## Joint Note

In compliance to CLW letter no. C-D&D/T/24(Part)/MV, Vol. VI (Part-II) dated 05.08.2024 and joint note dated 30.07.2024, firm has uploaded new software version. Further functionality and performance testing was done on 30.08.20234 and the observations are as follows:

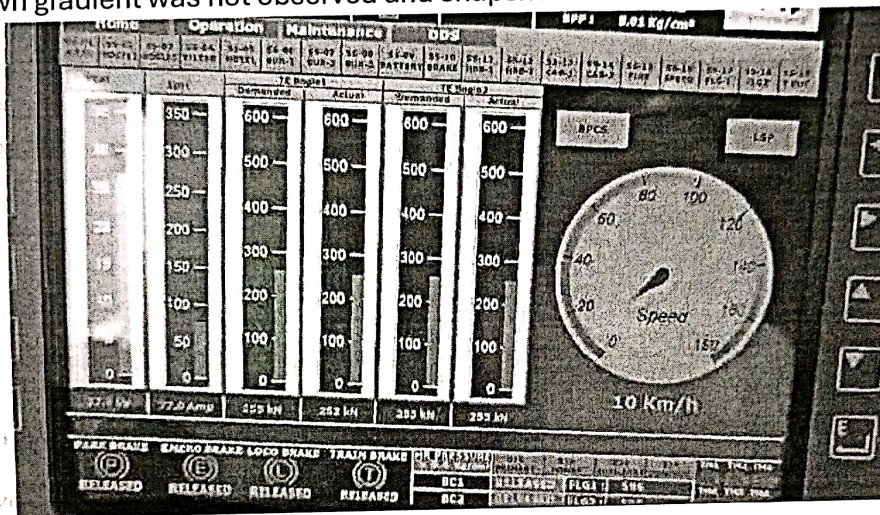
2. Graphical user interface (GUI) to monitor the healthiness of each motor has been implemented in DDU and same has been verified. Also Screen shot of same is attached below for reference

TE VS TIME

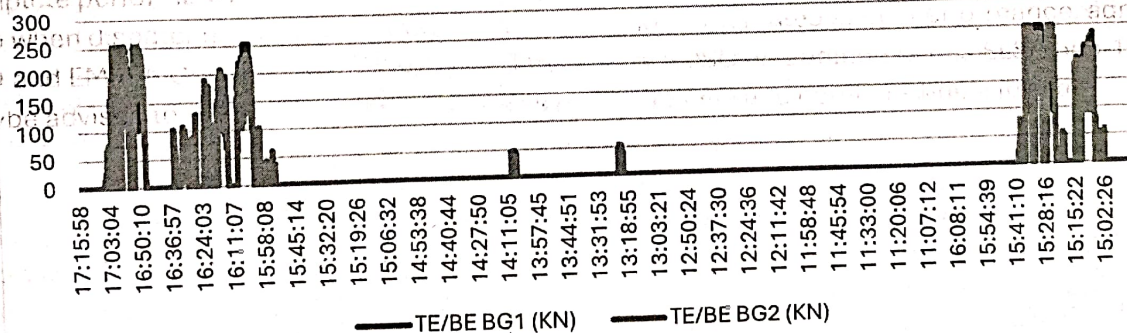
- On the day of testing it was fair and sunny and no rain was there.
- In the up gradient the maximum tractive effort which was reached was 492 KN and the maximum speed was 9 KMPH. Wheel Slip appeared sometime but no tripping of Traction converter
- In down gradient the maximum tractive effort which was reached was 506 KN (254 kN for Bogie 1 and 252kN for Bogie 2) and the maximum speed was 11 KMPH. Wheel slip in down gradient was not observed and snapshot for the same is attached for reference.

In addition to this the TE curve for complete testing period is attached for reference

In view of above of it can be observed that slip slide control has been improved from last trial. Further presently the test which is carried out is with two locos which is connected back-to-back in regeneration mode and the loads are simulated. However more precise tuning may be required for matching the actual service condition during field trials. Also, due to speed and track limitation the complete performance can't be checked at higher speed so firm maybe advised to do foot plating of loco when dispatched from CLW. Further firm may also be intimated about Performance, adhesion, EBD and EMI/EMC/RFI test which will be conducted by RDSO. In addition to this ELS/Shop-19/CLW maybe advised to do the pre despatch tests as per the testing and commissioning format.
